SUBJECT: F400/F410 Dual Job Feeder separation belts
(manual correction)

FROM: Copier Technical Support Group

MODEL: F400/F410

Page 7 - upper illustration

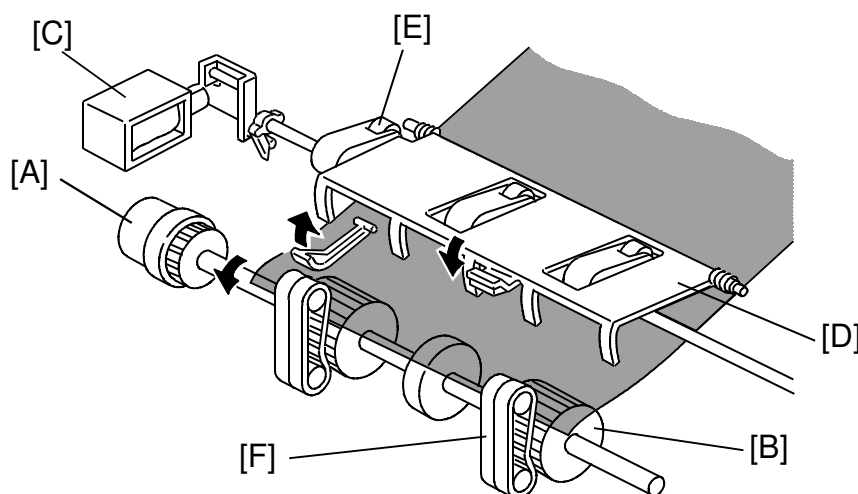
The quantity of the separation belt have been changed from two to four.

On the original printed by the laser printer, the toner may not be fused sufficiently and the image may smeared by the separation belts.

To prevent this, two more separation belts are added to widen the contacting area between the separation belts and the original so that the separation pressure is not concentrated to the narrow area.

Because of this modification, the illustrations in page 7, 14, 15, 34 and 35 should be changed. The quantity of the separation belts should be doubled. There is no correction except illustrations.

Guide mylar ass'y : Part number A3761254

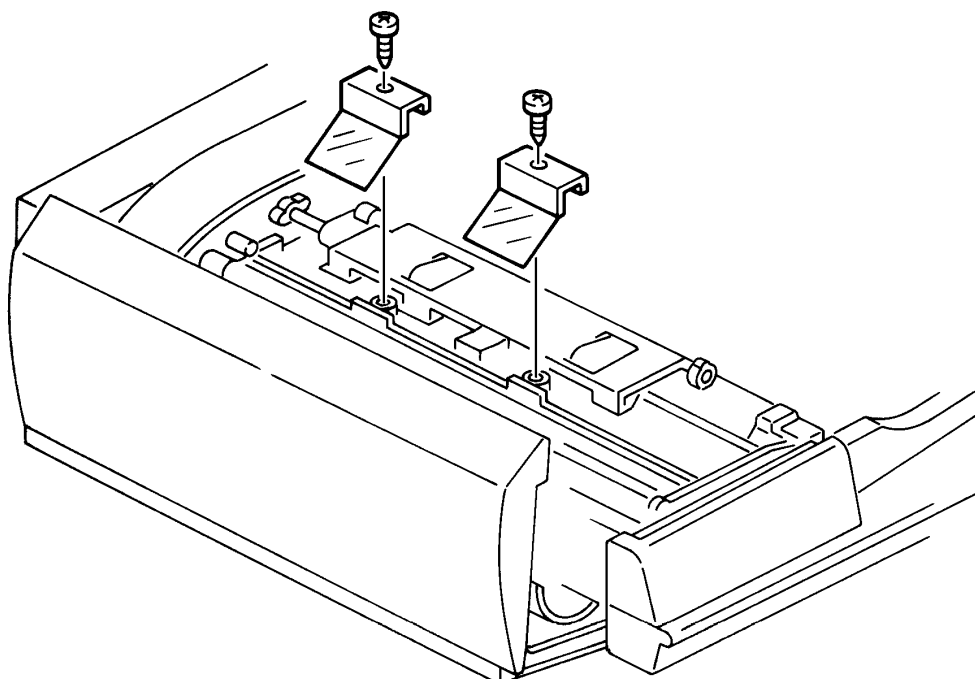
Original multiple feeding occurs when there is high friction between the originals. This tends to occur especially when the originals have staple holes, or computer forms with rough edges.

When the originals [A] comes between the feed rollers [B] and the separation belts [C], they meet the mylar [D] between them and the separation belts. This guide mylar transports the originals smoothly to the gap between the feed rollers and the separation belts. The mylar length determines the original separation force. If the mylar is longer, the area where the originals touch the separation belt becomes narrower, therefore the separation force become weaker. If the mylar is shorter, the separation force becomes stronger. (If it is too short, too much separation force stops original feed)
As a result of our investigation, we found that making the mylar 2mm shorter is the best condition (higher separation ability without feeding error).

Replace the original guide mylars (2 mylars per machine). New part is the assembled part of the mylar and the bracket. New part number is A3761254.

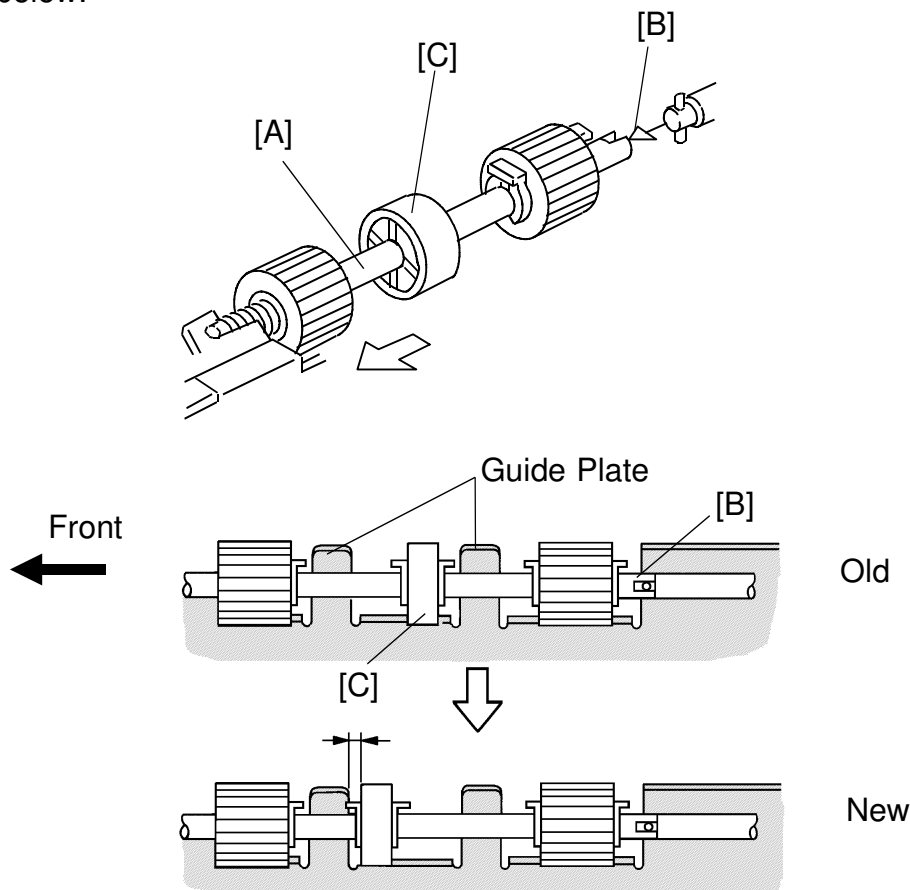
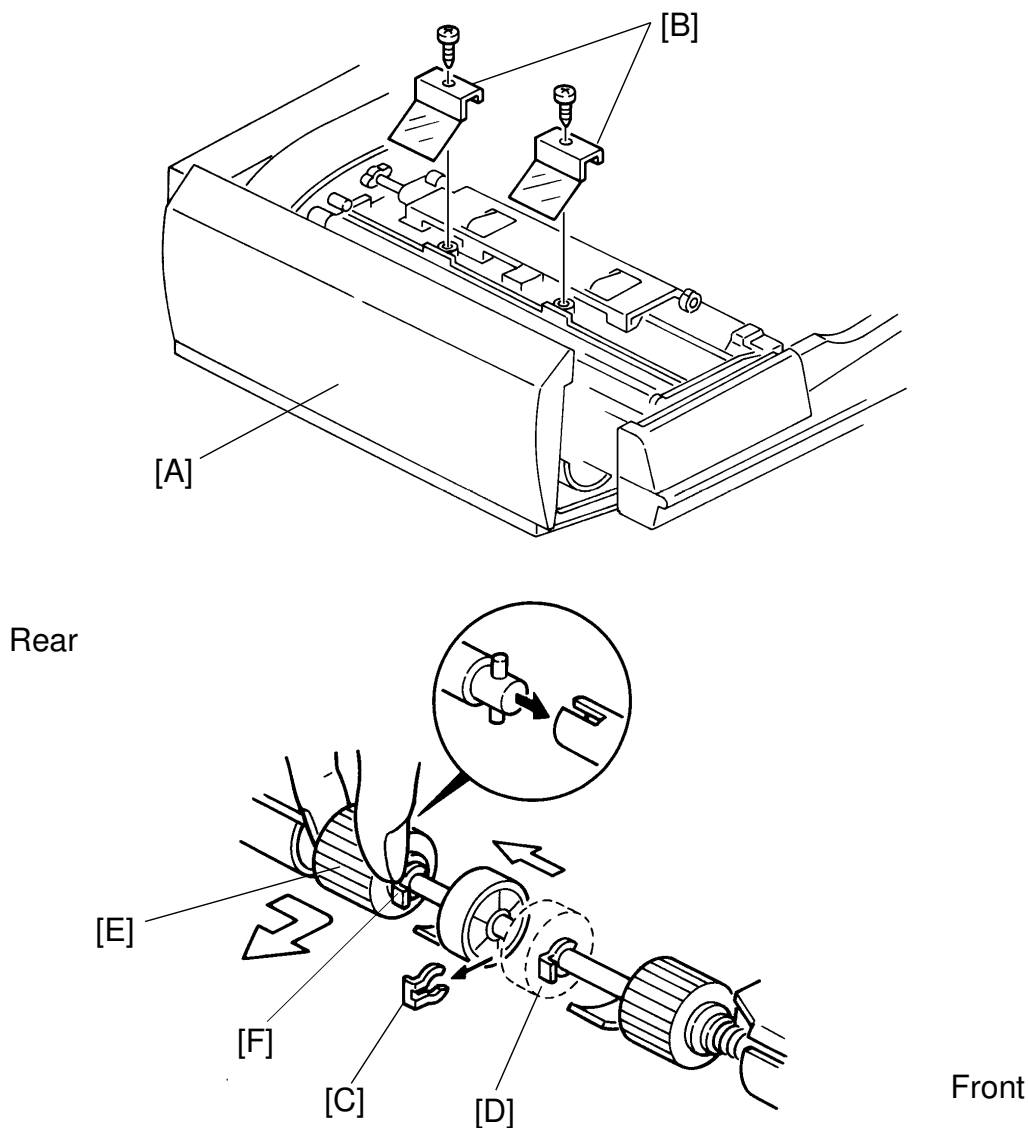
In the domestic market, we have experienced that the customer took off the feed roller assembly [A] when removing a jammed original. When the jammed original is pulled to the front, the feed rollers are pulled to the front and the joint part [B] comes out from the drive shaft. To prevent this, The middle roller [C] position has been changed (to the rear) as shown below.

Before the modification, the middle roller could be shifted to the front when the feed roller was pulled to the front. After the modification, when the feed roller is pulled to the front, the middle roller hits the guide plate and it cannot be moved to the front. This prevents the joint part from being separated by mistake.

To replace the feed roller assembly, the following procedure is necessary before performing step 6 (slide the feed roller assembly to the front, then remove it).

- * Remove the guide mylars
- * Remove the snap ring.
- * Hold the feed roller.

After the modification, procedure "14.2 feed roller replacement" is changed as shown in next page.

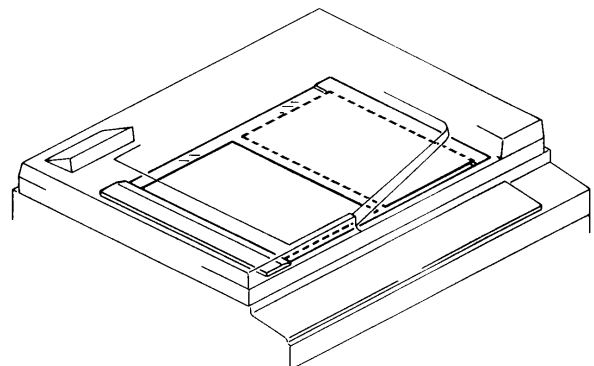
- Incorrect

In Fig.2, the left paper is expressed by a dotted line and the right paper is expressed by solid line.

In Fig.2, the left paper position is shown by a solid line and the right paper position is shown by a dotted line as shown.

Page 27 of DJF 3rd line of upper NOTE and Illustration

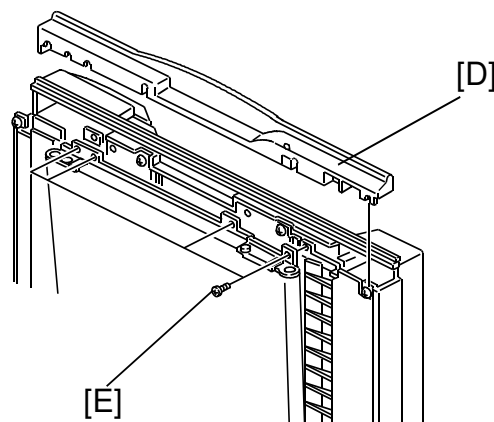
- Incorrect
..... loosen four truss head screws [D], and tighten.

- Correct
..... remove the cover [D] (4 screws), and loosen then tighten 4 screws [E].

Page 43 of DJF Illustration

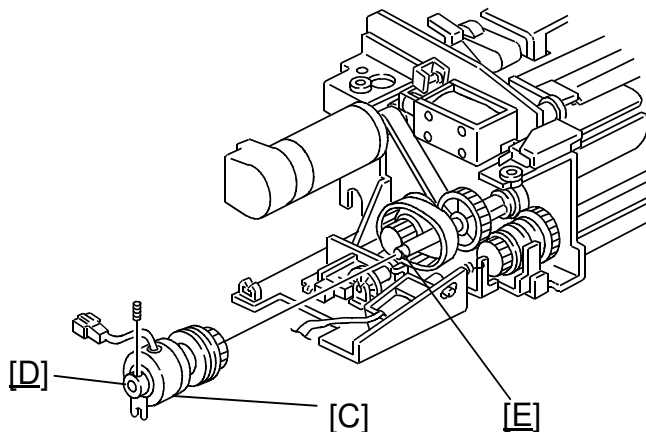
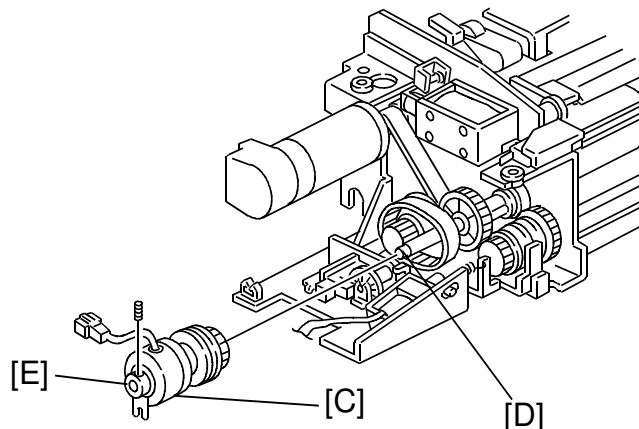
- Incorrect

- Correct

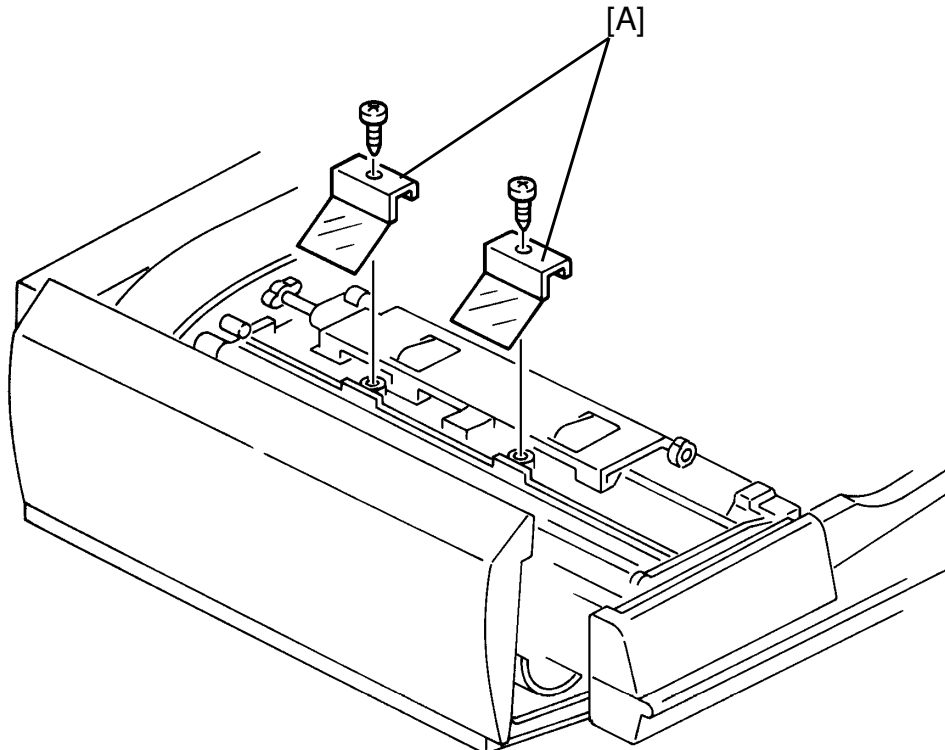
Note: If block original feeding (10~20 sheets of originals are fed at a time) occurs, replace the original guide mylars [A] to the new parts (A3761254). Please refer to RTB-008 for the details.
